Subject: Waterford 3 SES  
Docket No. 50-382  
MASONRY BLOCK WALLS

SUBJECT: LOUISIANA POWER & LIGHT COMPANY  
WATERFORD STEAM ELECTRIC STATION  
1984 - 1165 MW INSTALLATION - UNIT NO. 3  
FOLLOWUP ACTION PLAN FOR CLOSURE OF MASONRY  
BLOCK WALLS CAT ITEM 6.2/6.3

Attached is the list of confirmatory items emanating from the NRR audit of the Masonry Block Wall design and installation. Four (4) of the sixteen (16) items have been resolved. Closure of the remaining items will be accomplished as follows:

WALL H13 VIEW LOOKING NORTH

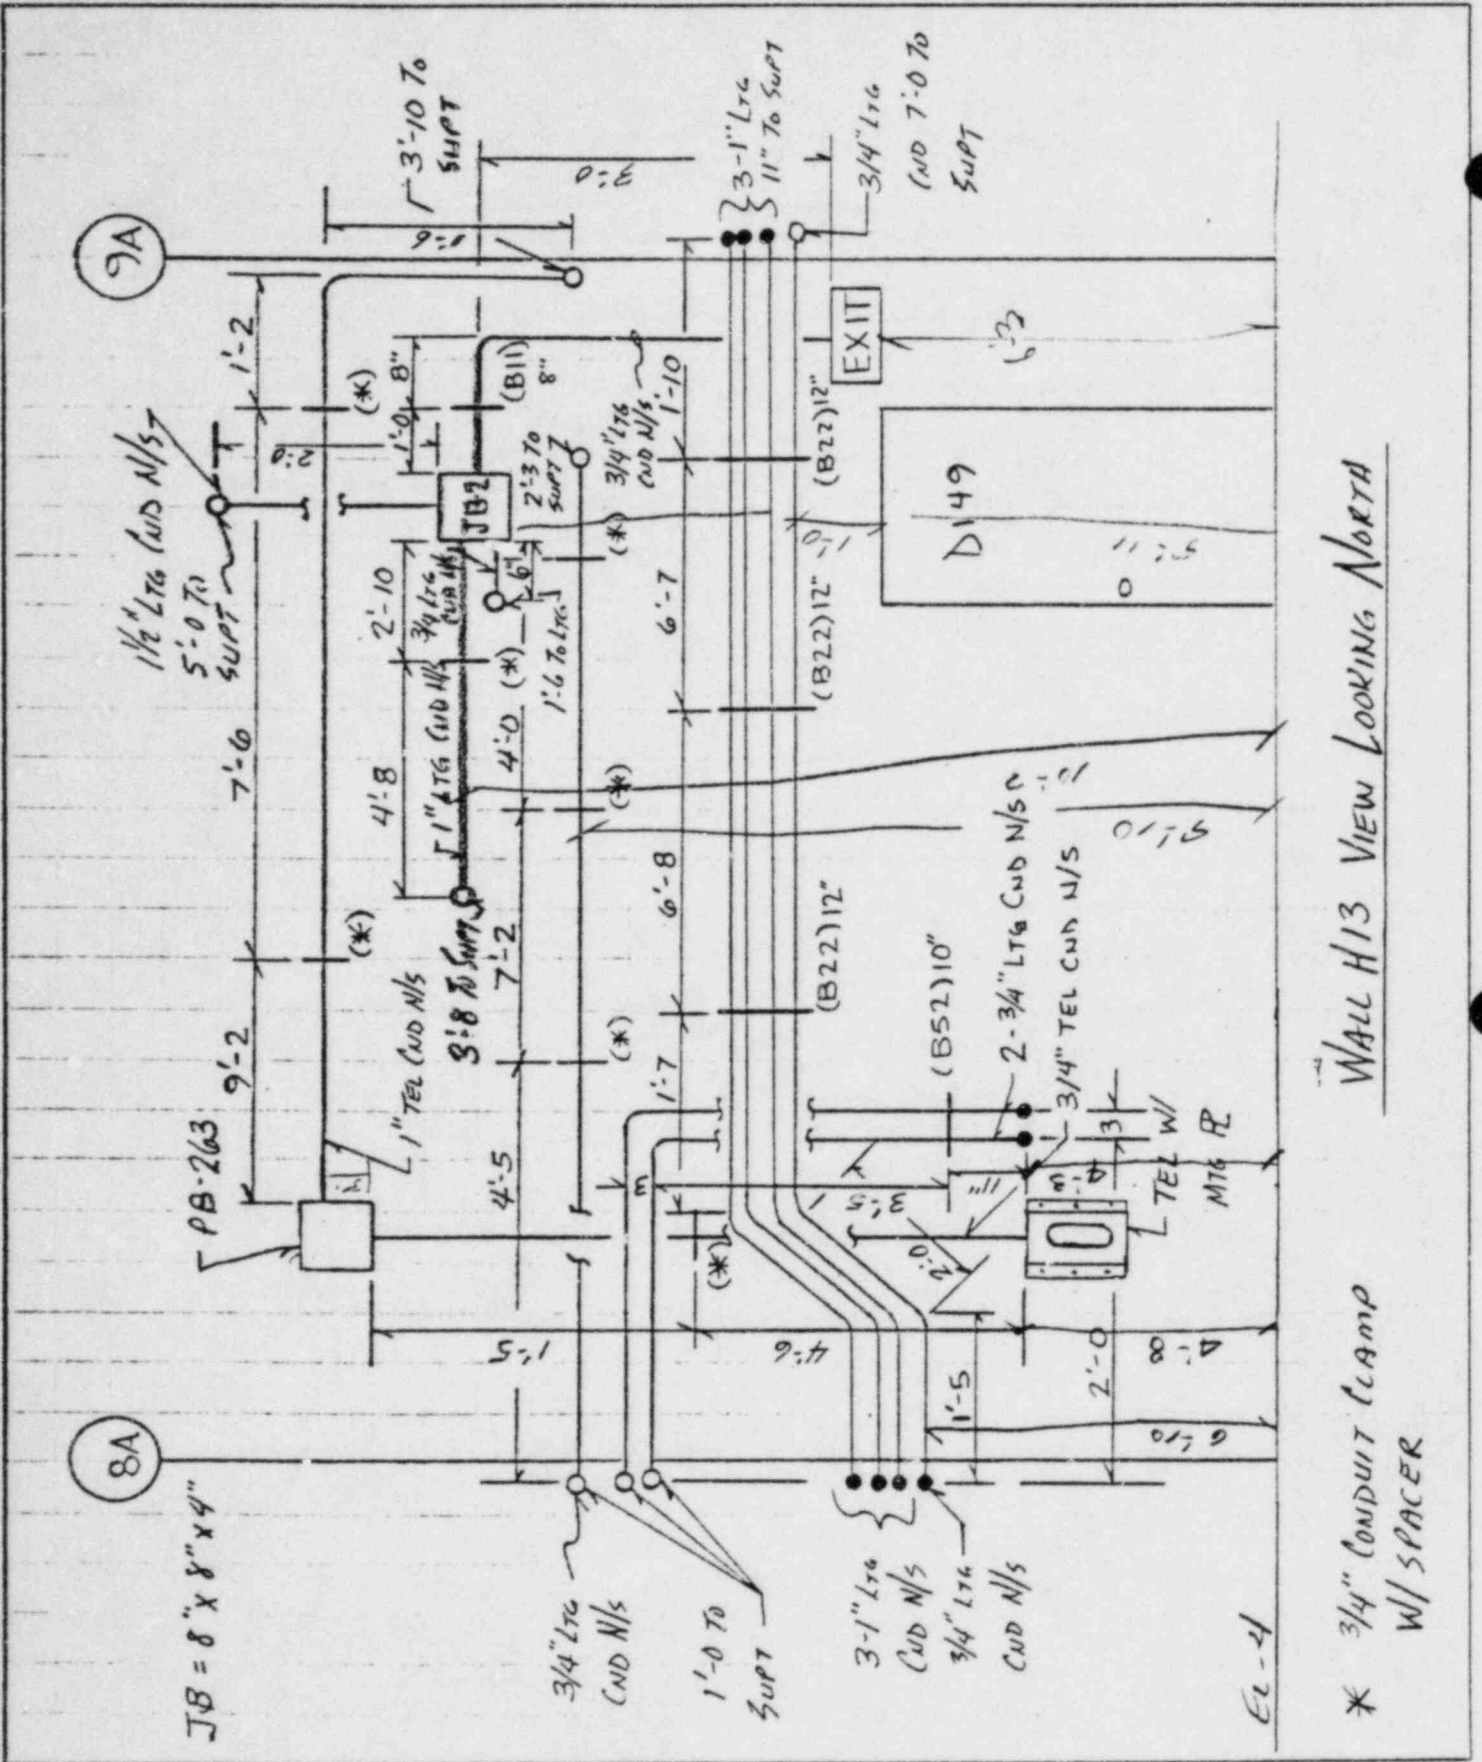
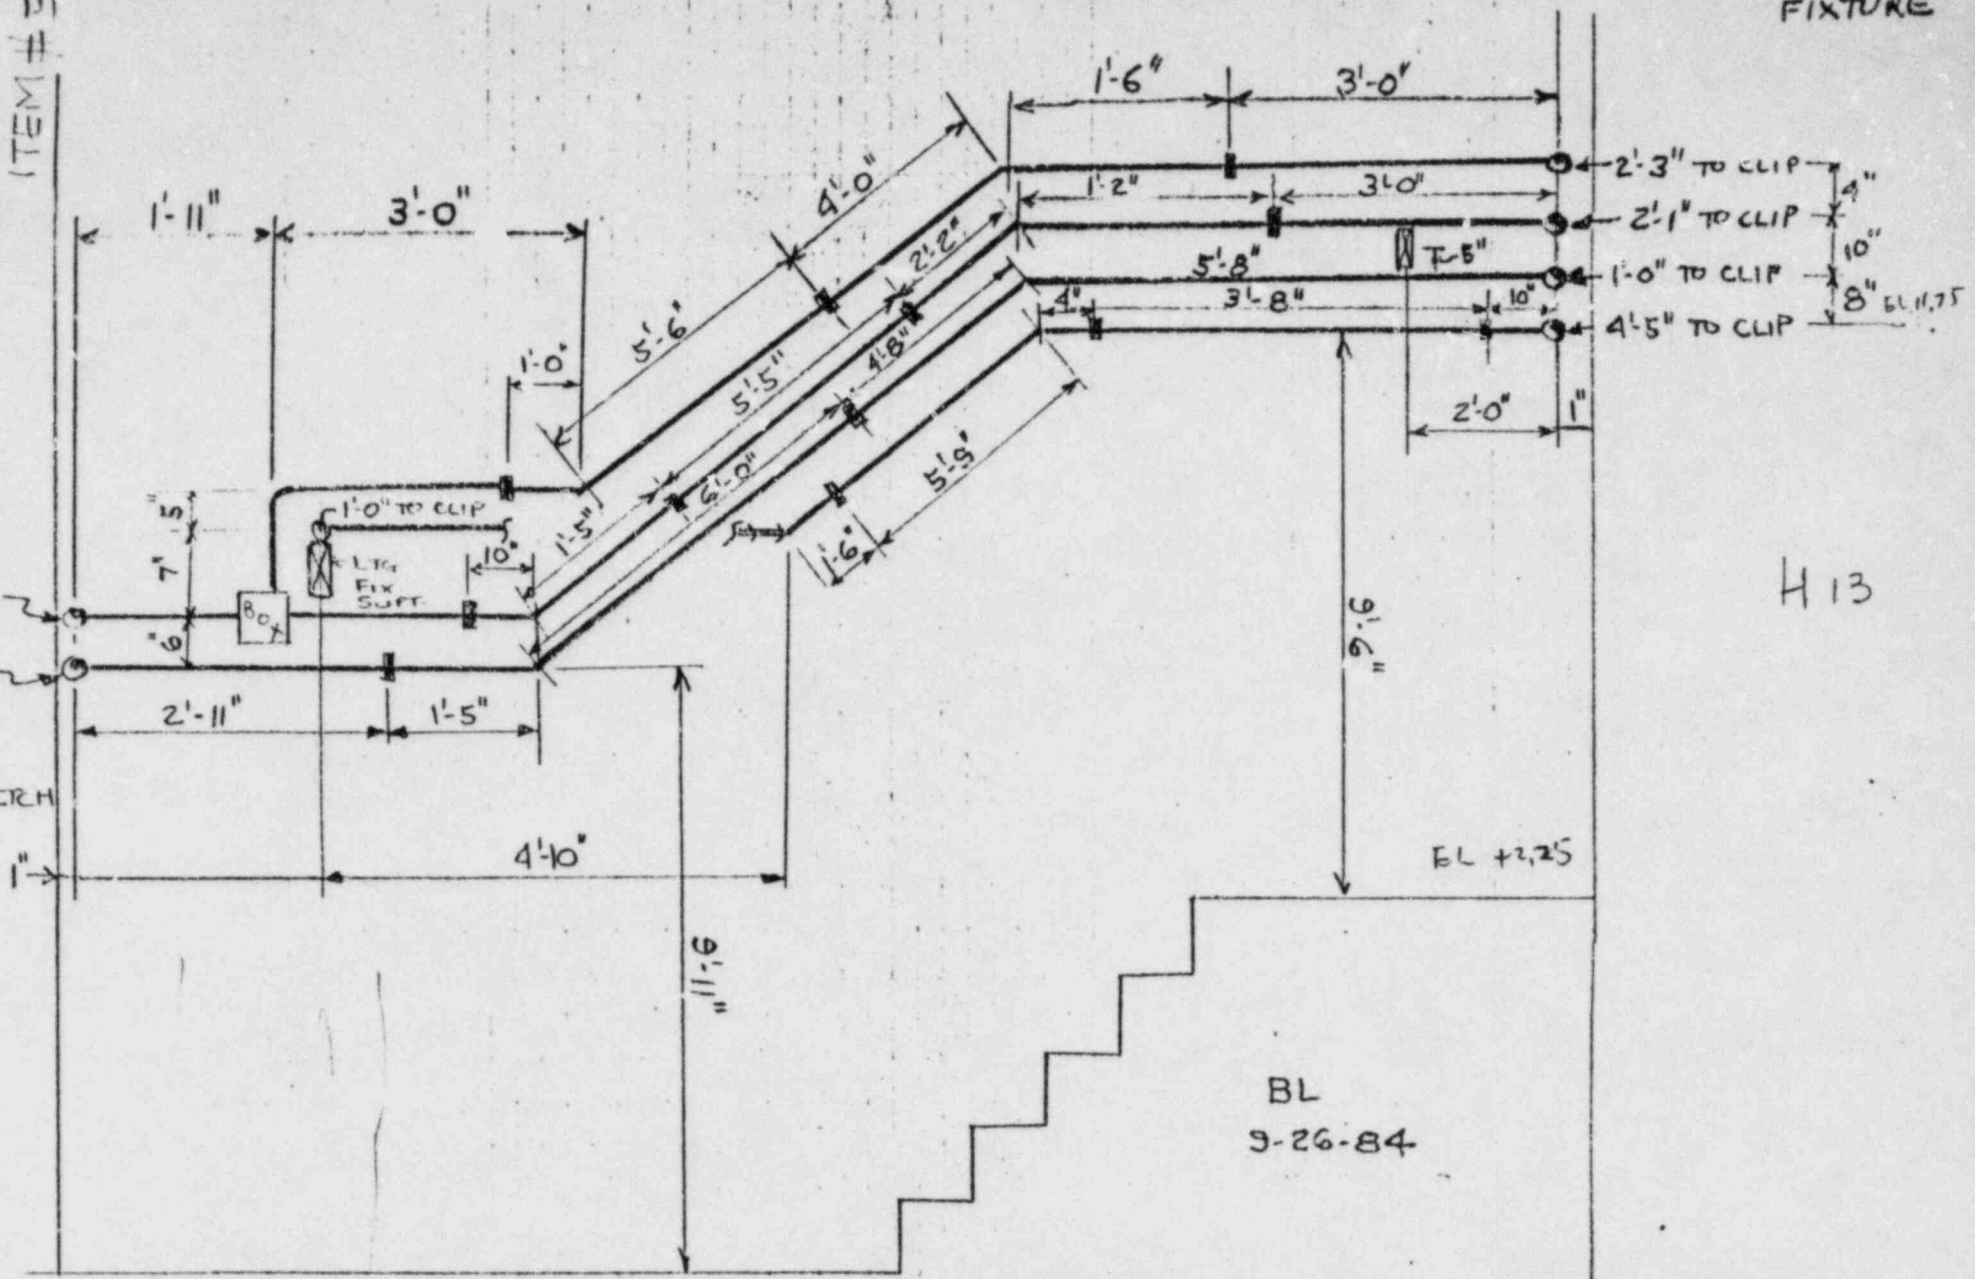
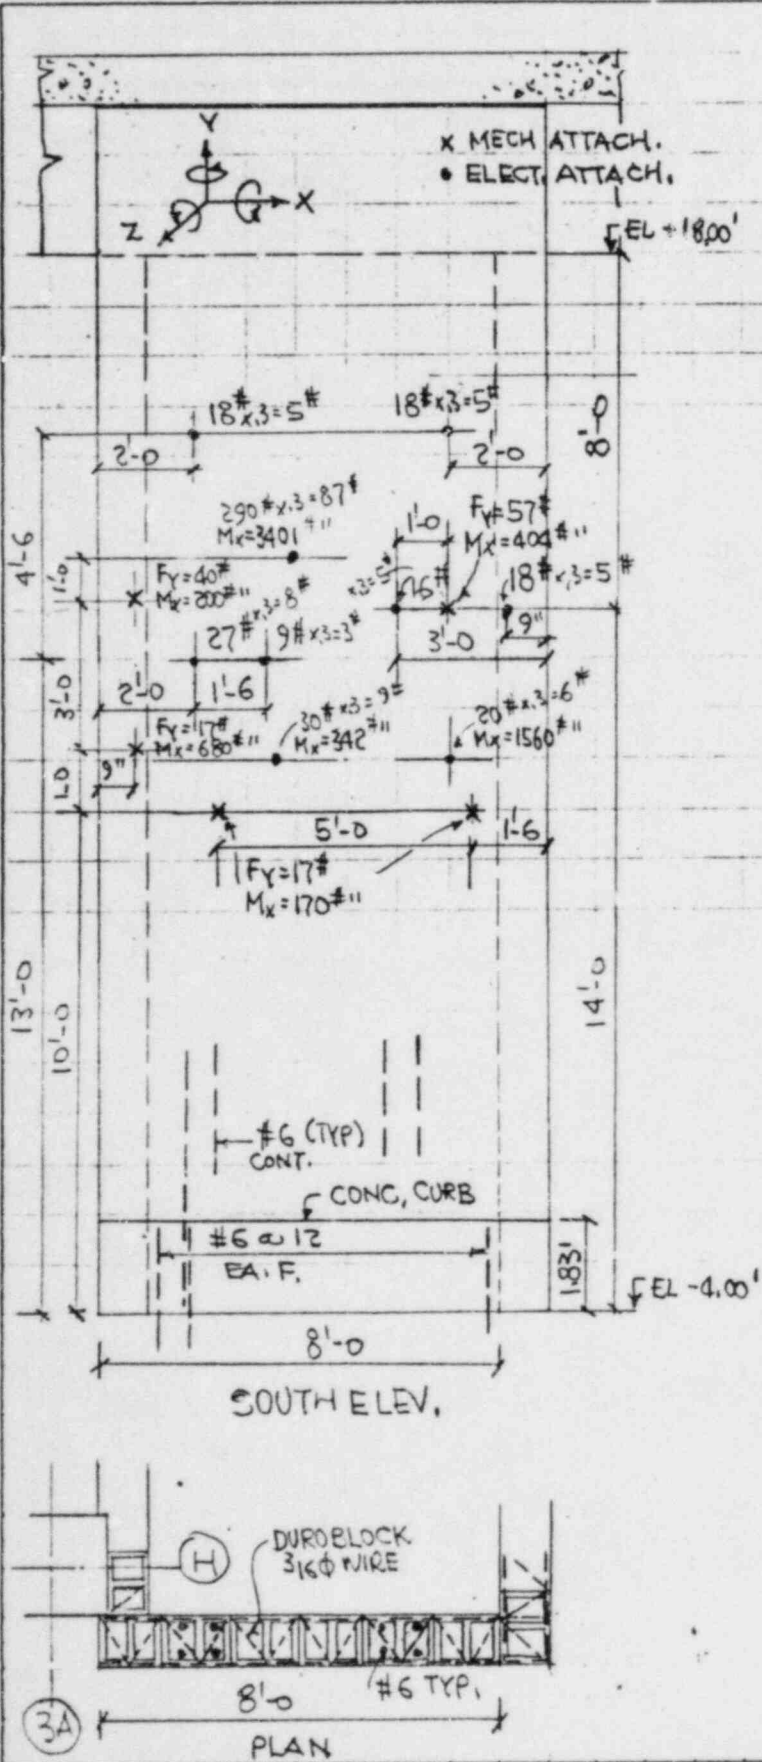
ITEM NO.	NRC REVIEW STATUS	QUESTION	RESPONSE
5.	Open	Verify the structural adequacy of Masonry Walls when miscellaneous non-seismic loads are considered. Select Walls S1, H2, H13, and W29 for this analysis.	Calculation Package No. 5 provides verification of wall S1. Verification of walls H2, H13 & W29 will be provided by 10/8/84.

SHEET OF 3  
 ITEM # 7

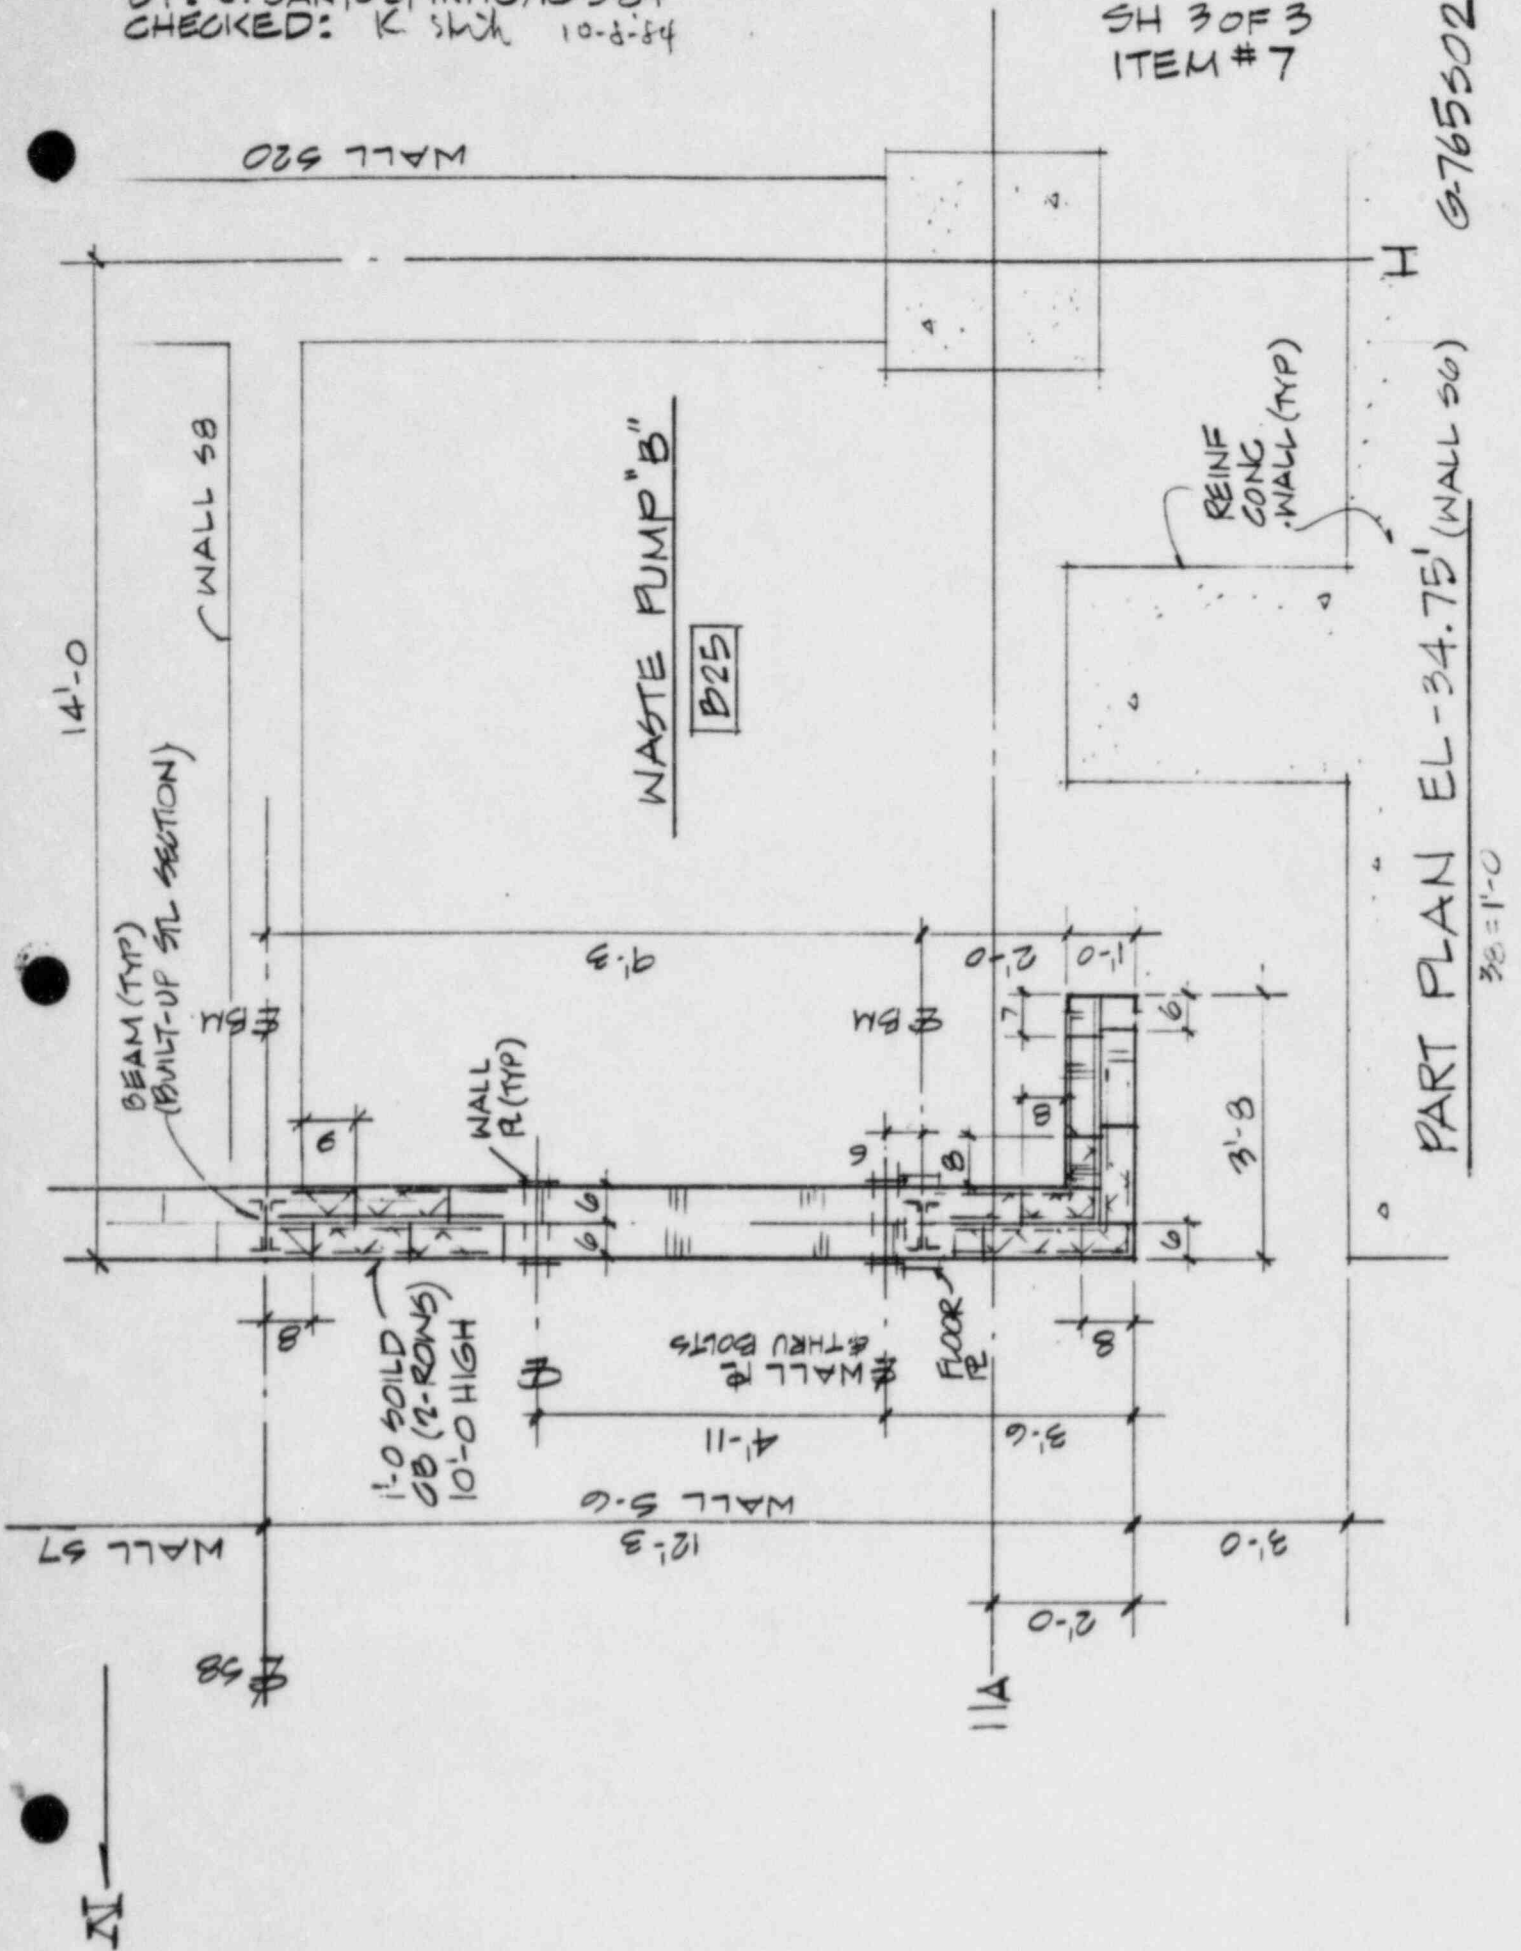
7.	Open	Provide connection details between perpendicular block walls and block wall to reinforced concrete wall, and L-shaped wall connections to diaphragm. (Example S6)	Connection details & specifications are provided in Package No. 7.
